| CONNECTOR | RJ45 180度SMT带壳 | MJ882-BX11-H9PS1-P |

MJ882-BX11-H9PS1-P

東莞市合陵電子有限公司
DongGuan Heling Electronic Co.,LTD

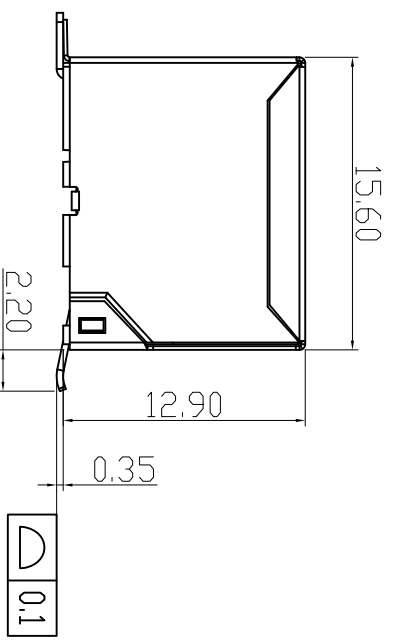
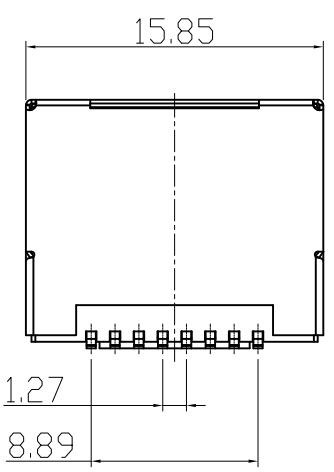
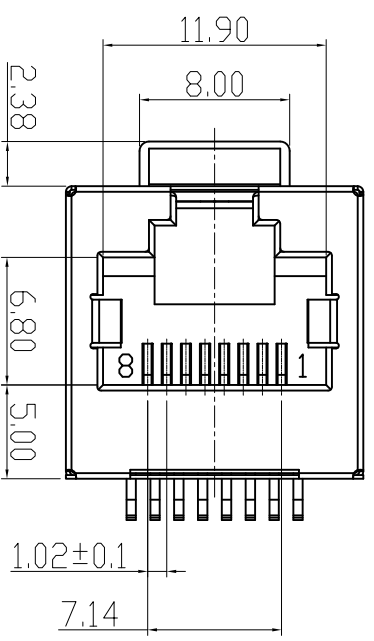
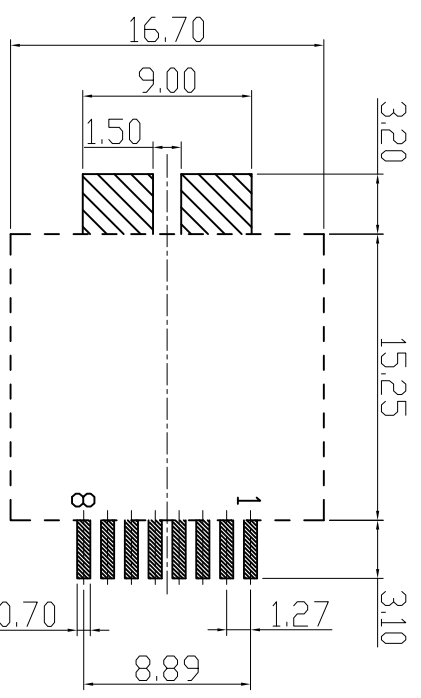
由原料号 MJ882-BX11-H9PS1 变更为 MJ882-BX11-H9PS1-X
